Seabrook Station  
Seabrook Station Emergency Response Manual Revision 90

Enclosed, please find Revision 90 to the Seabrook Station Emergency Response Manual (SSER). This revision was reviewed per the criteria of 10 CFR 50.54(q) and it was determined that it does not decrease the effectiveness of the Seabrook Station Radiological Emergency Plan (SSREP). The SSREP continues to meet the standards of 10 CFR 50.47(b) and 10 CFR 50, Appendix E. These changes are submitted per the requirements of 10 CFR 50, Appendix E, and 10 CFR 50.4. The Resident Inspector copies are provided directly through the North Atlantic records management system.

**CHANGE INSTRUCTIONS**  
**EMERGENCY RESPONSE MANUAL**  
**(SSER)**

**Assembly Area Operations**

**Figure 1  
Assembly Area Layout**

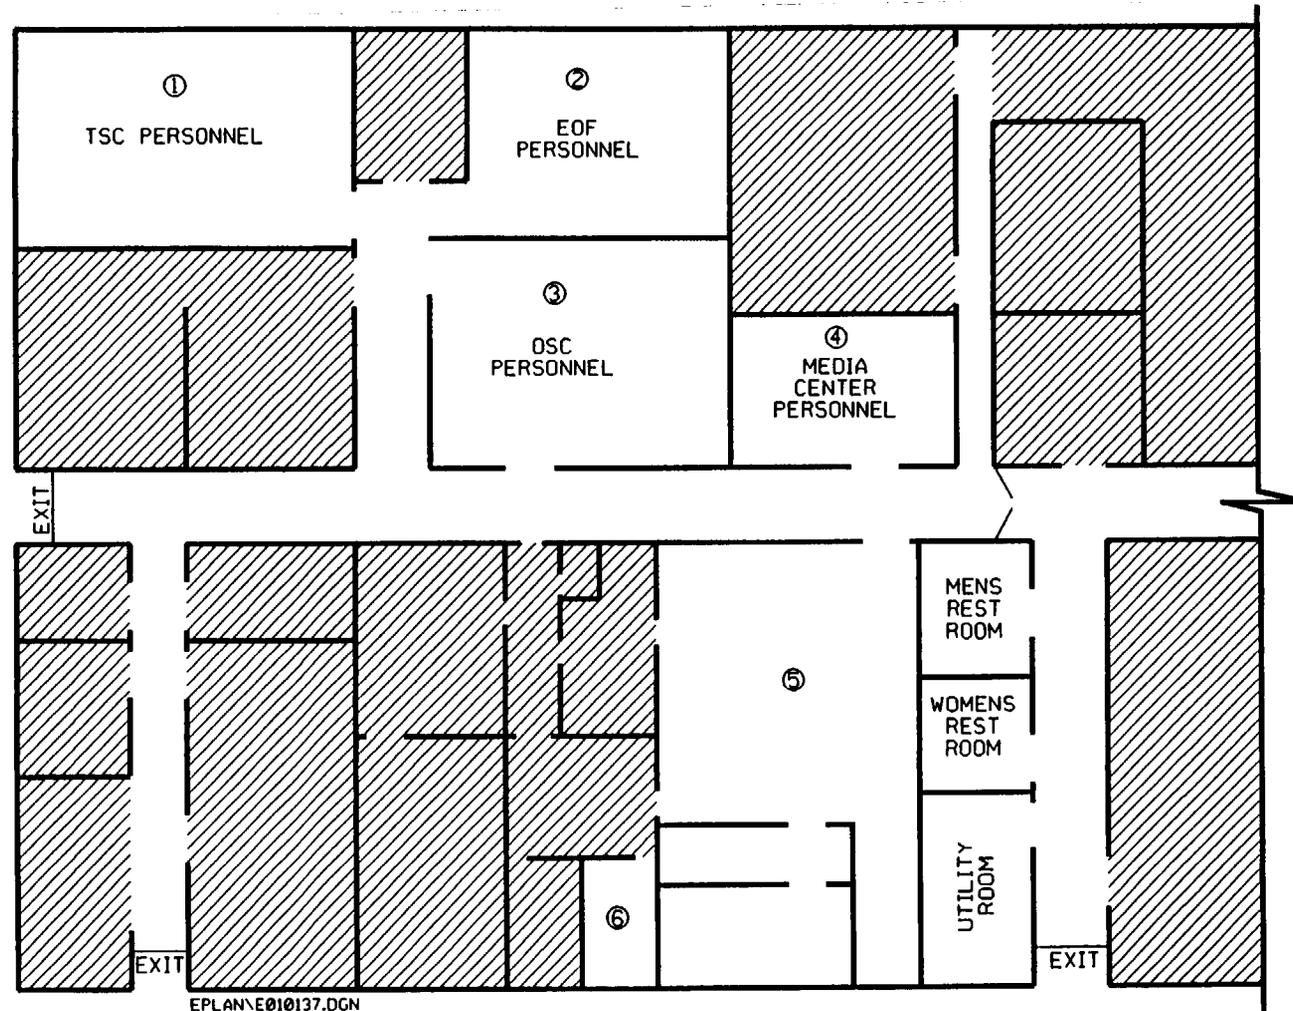
In Figure 1 deleted reference to JTIC staff in Assembly Area Layout.

**Figure 2**  
**Map to the EOF and Remote Monitoring Area**

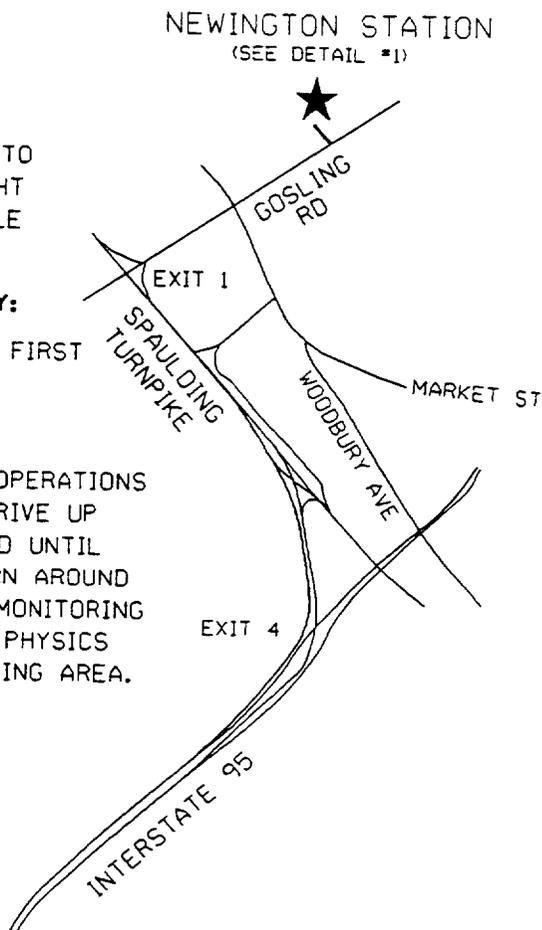
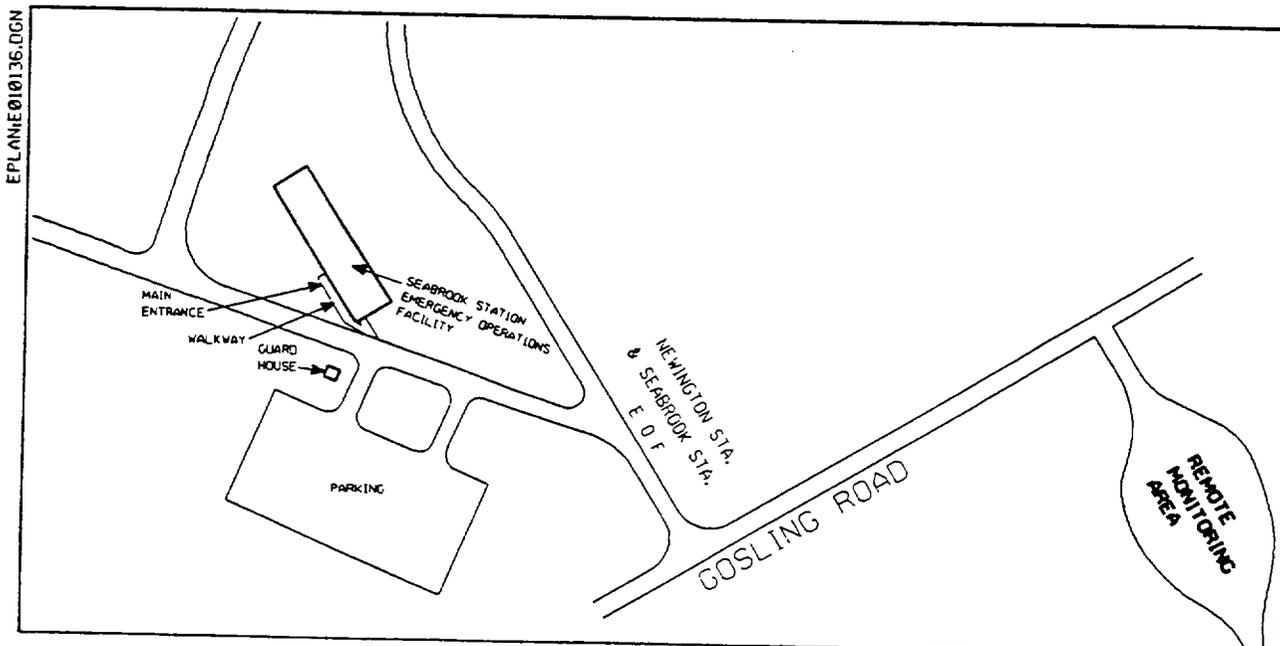
Revised Figure 2 to correct turnpike exit number.
